PROJECT
LAND TO HENHALL DRIVE,
CHELLASTON

DRAWING
PLANNING LAYOUT

DRAWING NO. CH_20-02_001			
DATE	SCALE	REV	DRAWN BY
MAR 2021	1:500 @ A3	C	DL

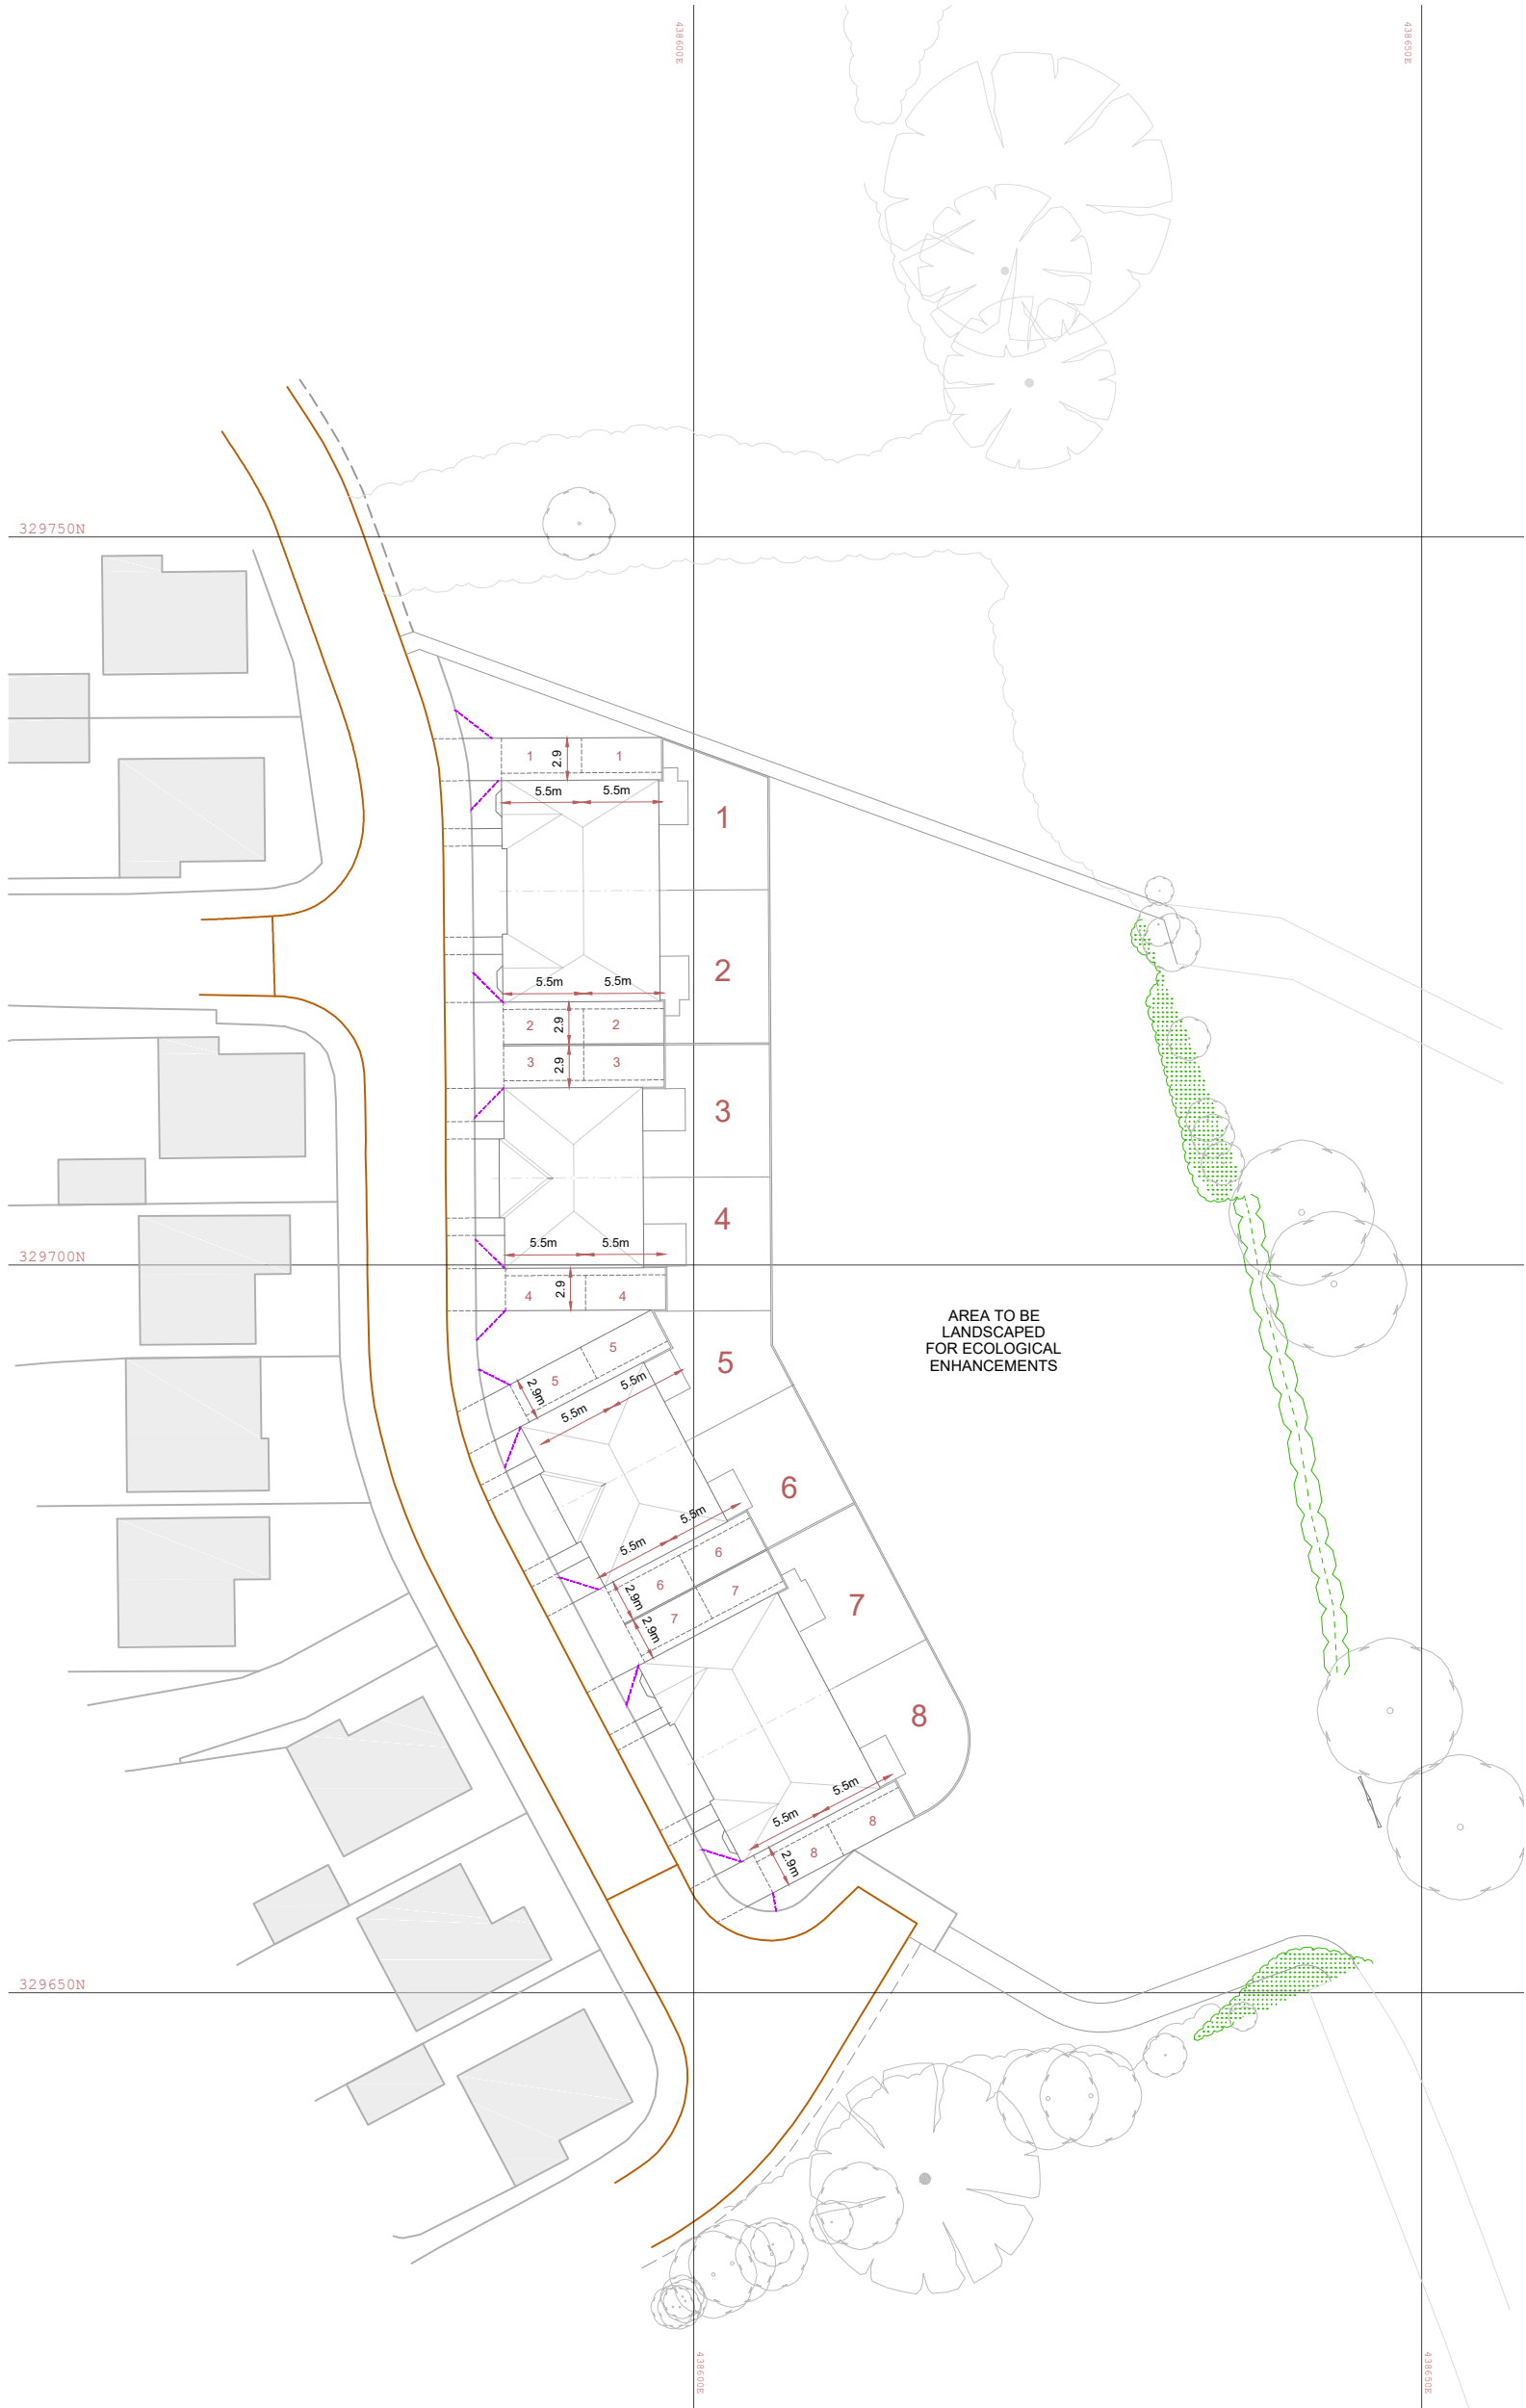
C	Parking space sizes increased in width to 2.9m & units updated to suit. Plots 3-6 sizes updated.	19/07/21	DL
B	Footpath fronting plots 1-8 increased in width to 2m. Parking space sizes updated to 2.4 x 5.5m & visibility splays now indicated to house driveway frontages.	28/06/21	DL
A	'Area to be landscaped for Ecological Enhancements' note added to drawing	07/04/21	DL
REV	DESCRIPTION	DATE	BY
